STAFF REPORT
COMMUNITY DEVELOPMENT DEPARTMENT

HEARING DATE: 09/17/2024

SUBJECT: Prescott Ridge Subdivision No. 4
FP-2024-0016

B. Final Plat (dated: 07/01/24)

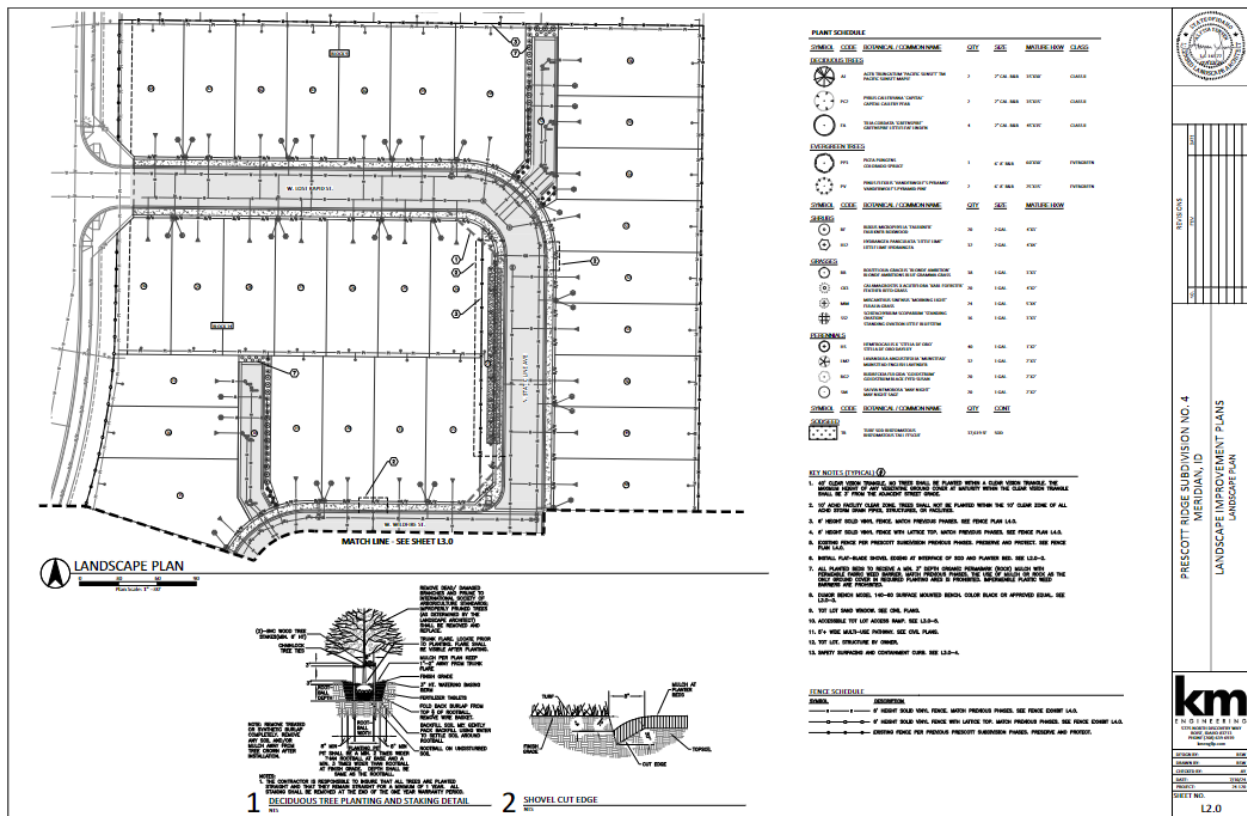
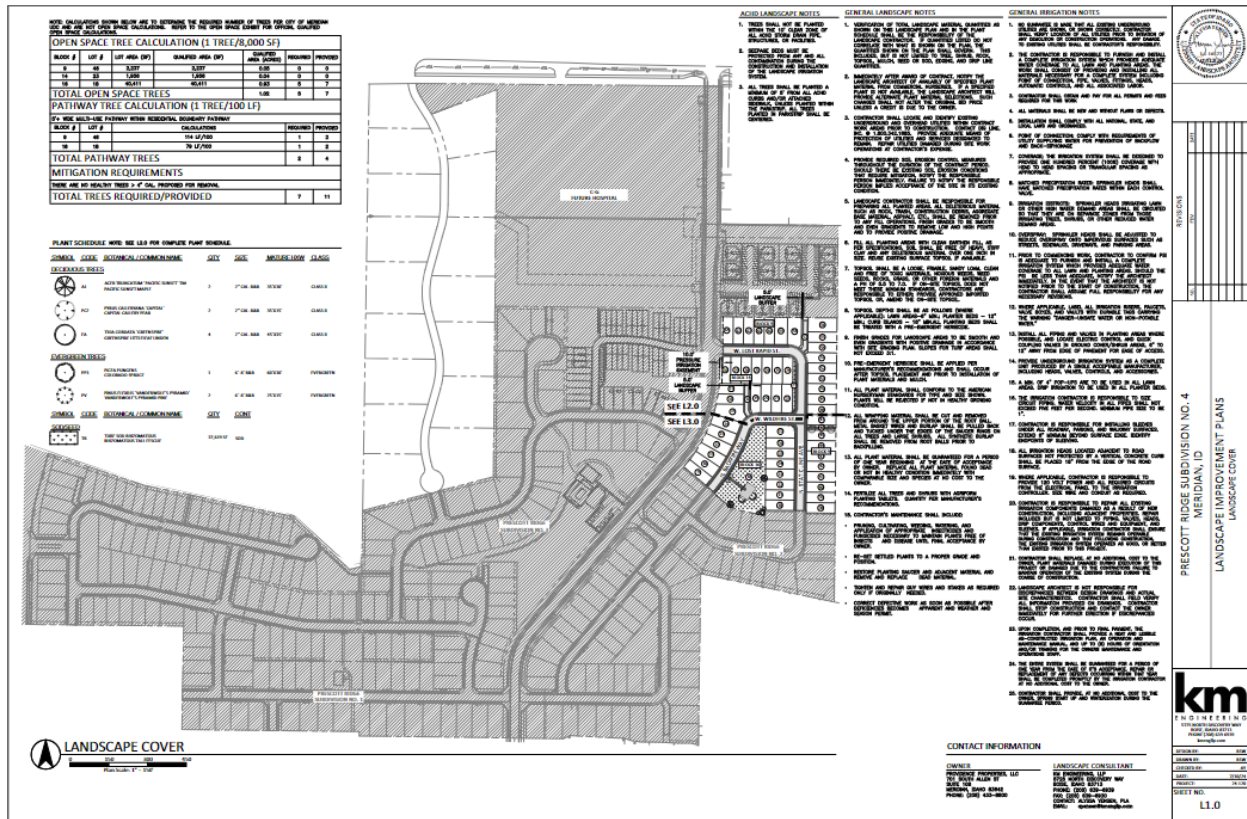
3. Prior to submittal for the City Engineer's signature, have the Certificate of Owners and the accompanying acknowledgement signed and notarized.
4. The final plat shown in Section V.B prepared by KM Engineering, stamped on 07/01/2024 by Aaron L. Ballard, shall be revised as follows:

- a. Note #15: Include the recorded instrument number for the ACHD permanent easement.
 - b. Under References, R4 – include the Book and Page numbers of Prescott Ridge Subdivision No. 2.

An electronic copy of the revised plat shall be submitted prior to signature on the final plat by the City Engineer.

C. Landscape Plan (dated: 7/12/2024)

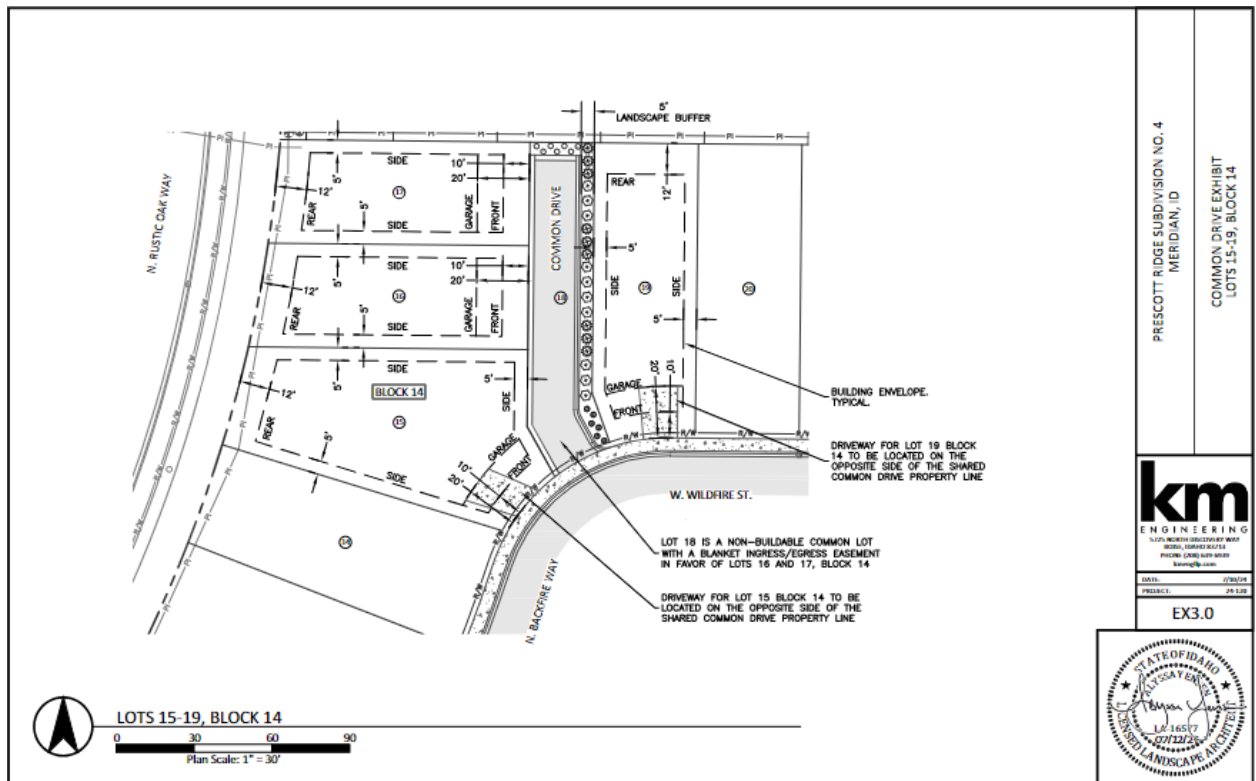
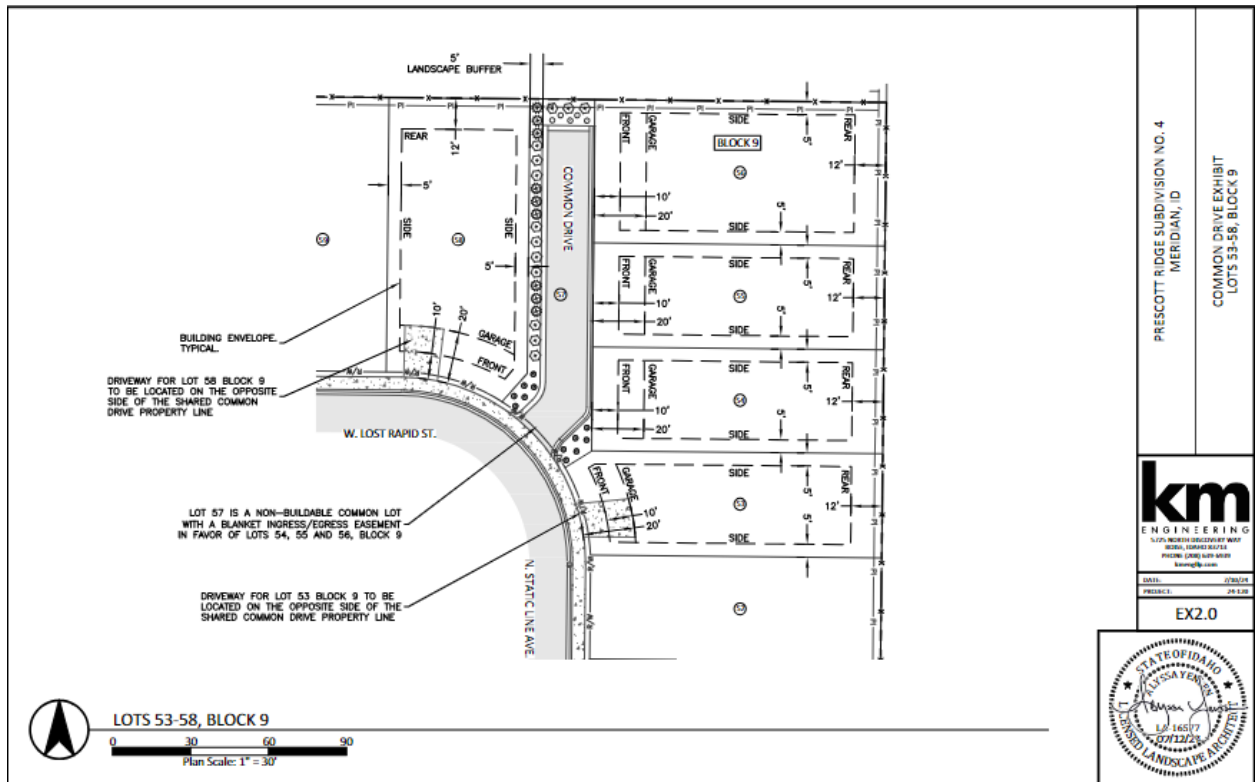
5. The landscape plan shown in Section V.C, dated 07/12/24, shall be revised as follows:

Revise the fencing along Lot 46, Block 5 to be 4 feet of closed vision and 2 feet of open vision.
6. Prior to the issuance of any new building permit, the property shall be subdivided in accordance with the UDC.
